Addendum No. 2 to

Proposed Change No. 3

Southwest Experimental Fast Oxide Reactor

January 27, 1971

Figure 1. Core Loading for Assembly I-J

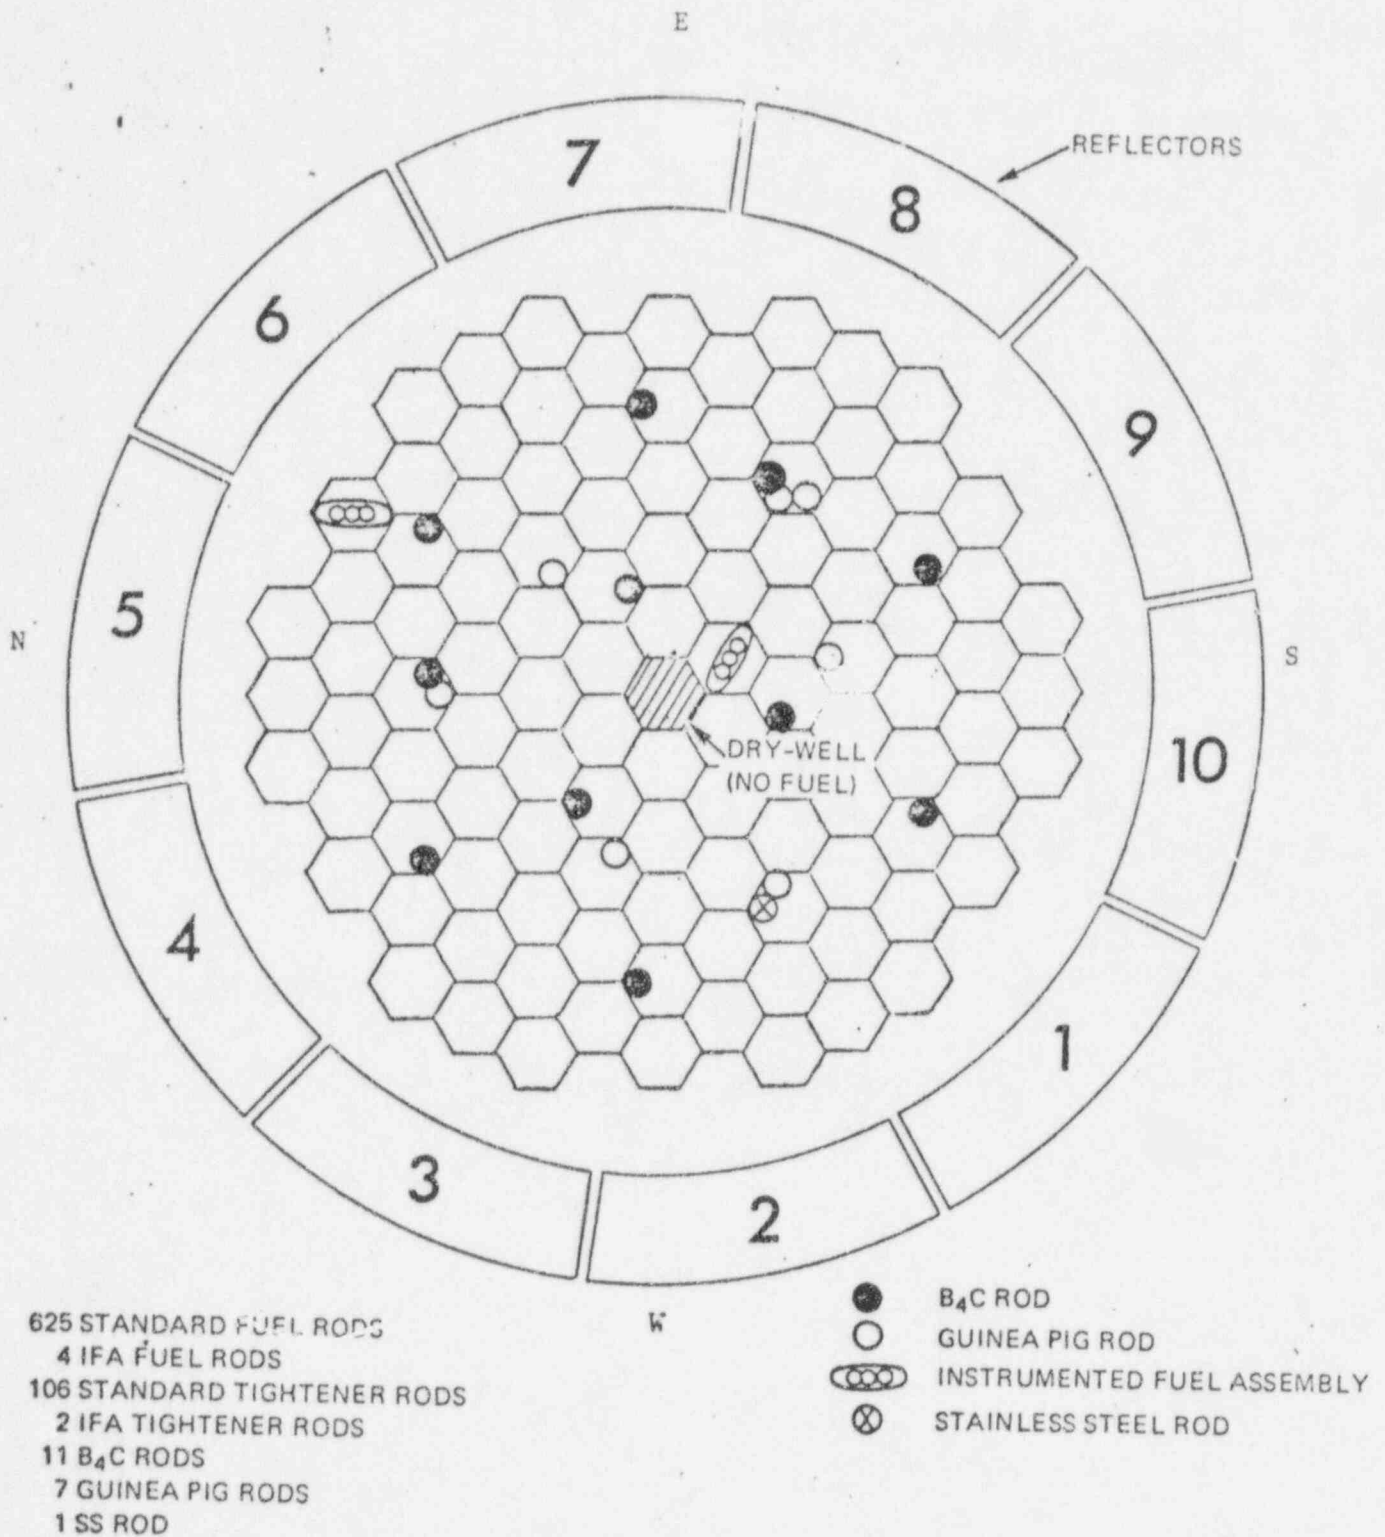
When additional poison rods are distributed throughout the core, their effects will tend to cancel each other. Figure 1 shows the arrangement of poison rods currently installed in the reactor. This arrangement was chosen to provide a reasonably uniform distribution of poison rods consistent with the needs of the test program.
